# SERVICE LETTER

No. 584

Piper Aircraft Corporation

Subject: 90 AMP Alternator Circuit Breaker Switch Inspection

SKETCH "A"

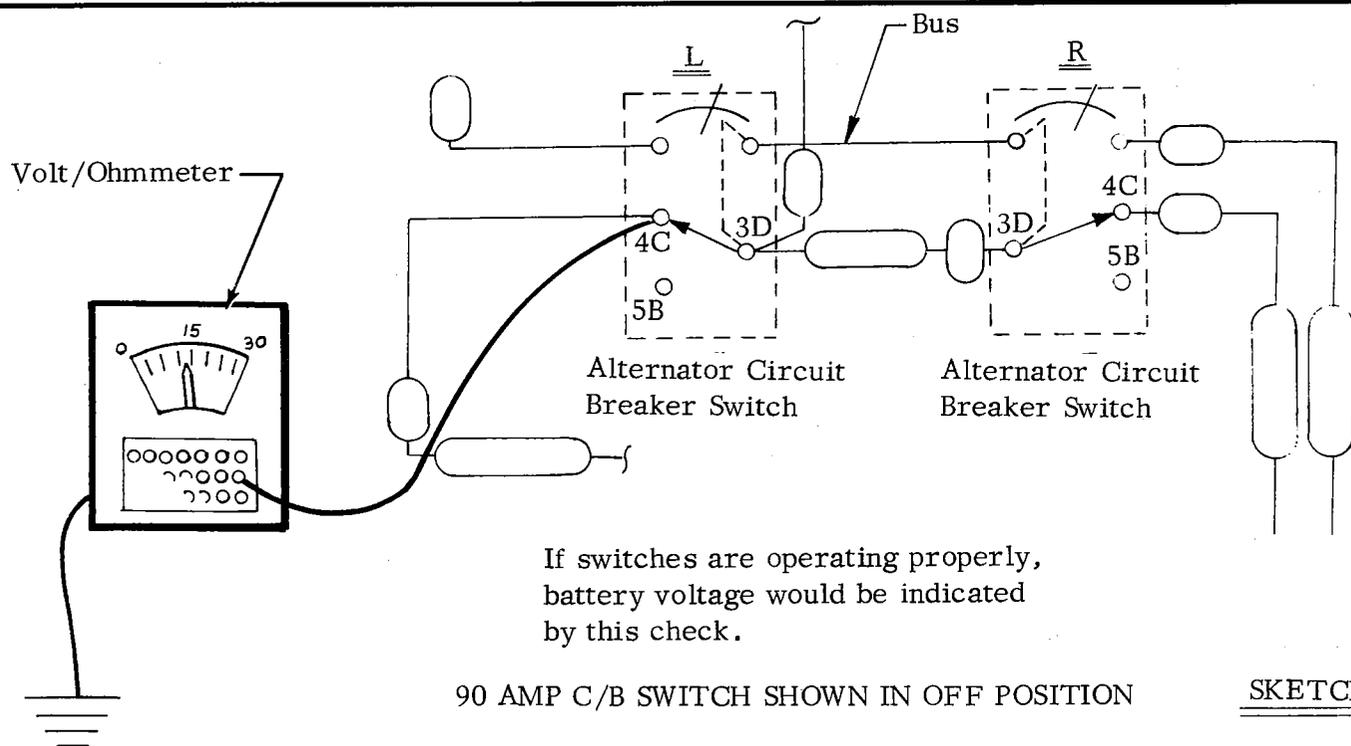
If switches are operating properly,  
battery voltage would be indicated  
by this check.

90 AMP C/B SWITCH SHOWN IN OFF POSITION

1. Turn the left and right 90 AMP Alternator Circuit Breaker switches both OFF.
2. Turn the aircraft Master Switch ON.
3. Connect a volt/ohmmeter as shown in Sketch "A".
4. Check the #2 Terminal of each alternator for voltage. Then connect the instrument lead to the #1 Terminal and check for voltage at this point. Do this on both alternators. If voltage is indicated at any of these terminals, proceed with Step 5. If there is no voltage, the alternator circuit breaker switch is all right.
5. Connect volt-ohmmeter as shown in Sketch "B". Check pin 4C of each alternator circuit breaker switch to determine if voltage is present. There should be voltage present; if there is, the switch is all right. If unable to obtain a voltage reading at pin 4C, the alternator circuit breaker switch being tested is defective and must be replaced with Part No. 454 667 (Wood #302-290-102).
